SUBDIVISION COMMITTEE
METROPOLITAN AREA PLANNING COMMISSION

STAFF REPORT
(Final Plat)

CASE NUMBER: S/D 92-34 - SOUTHERN KANSAS TELEPHONE 2ND ADDITION

VICINITY MAP:

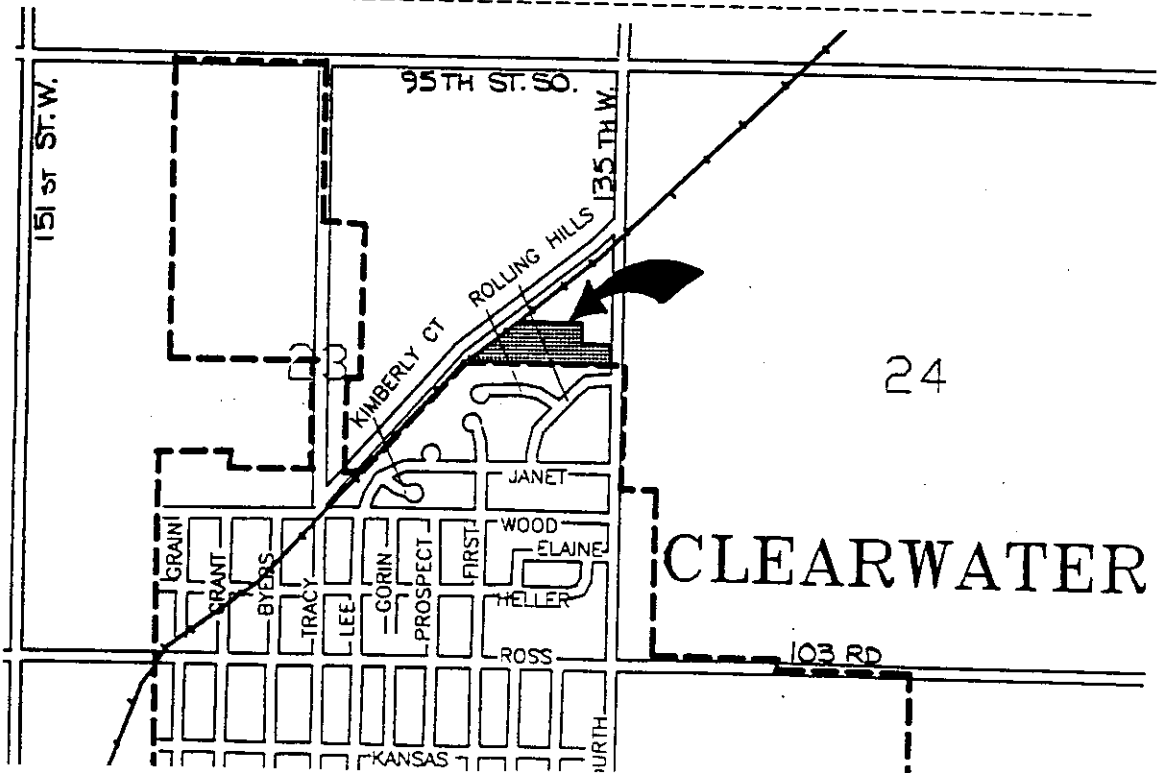
- NOTE: Although this site is in the County, it is adjacent to the City of Clearwater. Clearwater sanitary sewer and water facilities are also adjacent or near to this site. Zoning for the site is presently "E" Light-industrial which is apparently appropriate for the planned use.

- A. Since Clearwater's sanitary sewer and water facilities are adjacent or reasonably available for use by this site, the applicant shall make arrangements with Clearwater for the extension of sanitary sewer and municipal water to this Addition. A letter shall be submitted, from the City of Clearwater, indicating that such satisfactory arrangements have been made.

- B. The applicant shall guarantee any drainage improvements required by the platting of this property.
- C. If any of the site's drainage is to the railroad right-of-way to the west of the plat, a letter shall be provided from the railroad (Mo. & Pac.) indicating their willingness to receive such drainage.

- E. The setback along the south line of this plat is appropriate and is being provided to create a buffer between this site and the residential area immediately to the south.

- F. With regard to the access control shown for this site to 135th Street West, the following changes shall be made on the final plat tracing:
1. The word "complete" should be deleted from the face of the plat since an opening is being allowed.

2. The plattor's text should note that access control, except for 1-opening is being dedicated to 135th Street West across this site's east line. The text is now implying that complete access control is being dedicated.
